SUBJECT: IPE SENIOR REVIEW BOARD SEPTEMBER MEETING AGENDA

ST. LUCIE 1&2 BACK-END PRESENTATION

Human Reliability Analysis (HRA) Review
IPE for St. Lucie Nuclear Power Plant (Units 1 & 2)

Figure 3.7-2 St. Lucie Unit 1 Core Damage Frequency by Initiator

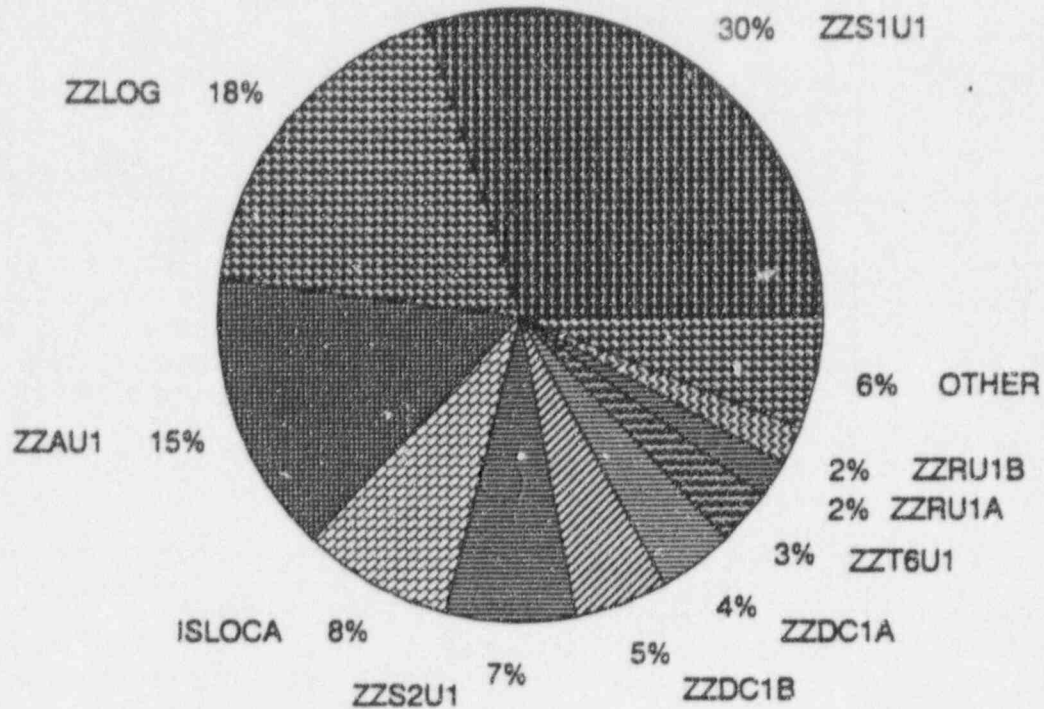
4 TER needs a statement about why LOCA contribution is so high. It should be known.
(No credit for recovery actions??)
